E6607C-01

S E R V I C E N O T E

E6607C – Multiport Wireless Communications Test Set

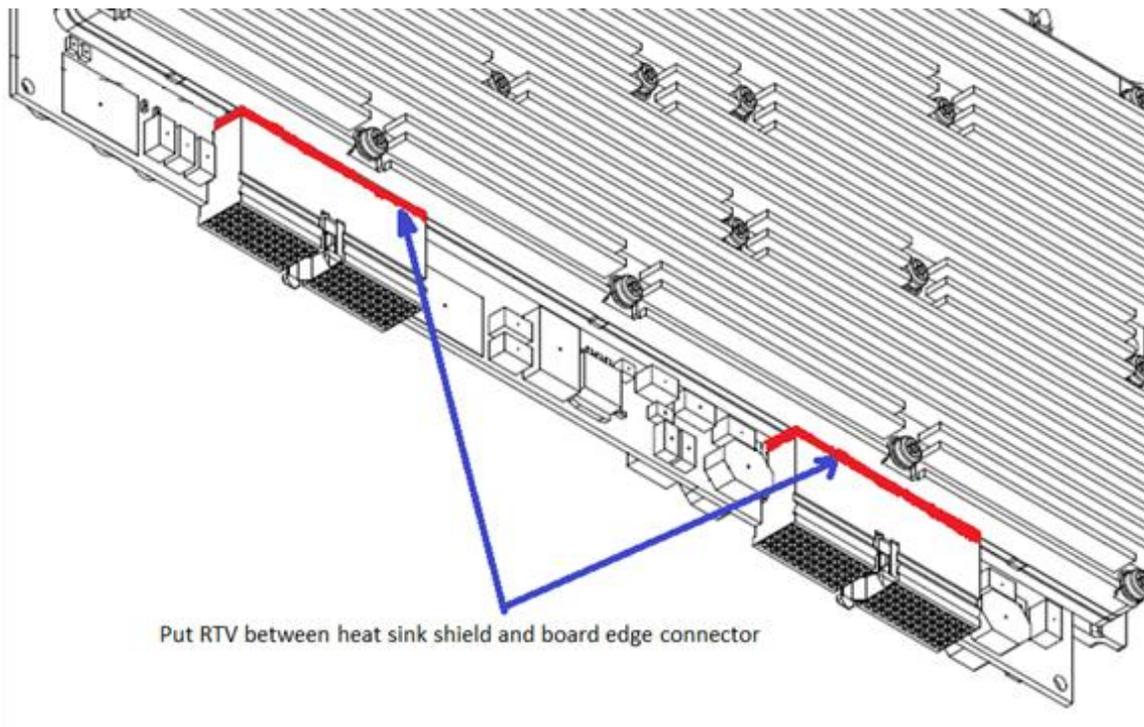
High warranty failure rates of the DC/DC converters on the E6607C Source boards. E6607C Source boards E6607-61850 use a larger heat sink. The weight of the larger heat sink results in the board to shake harder and vibrate more in transit. The increase flexing of the board causes the DC/DC converters to have cracked solder joints which causes loss of the DC supply. One of the errors seen is the "PCI Enumeration Time Out". Installing the Dow Corning 3145 RTV between the connectors and the shields stiffens the boards so that the board flexes less in the area where the DC/DC converters are mounted.

Remove the A29 RF Source assembly from the unit and Install Dow Corning 3145 RTV Silicon rubber between Heat sink and the shield. This will stiffen the boards so that it will flex less and prevents the cracks in the solder joints on the connection between the main board and the DC/DC converters.

Allow the RTV to dry for 30 to 60 minutes so that it does not weep into connector before assembly back into the unit.
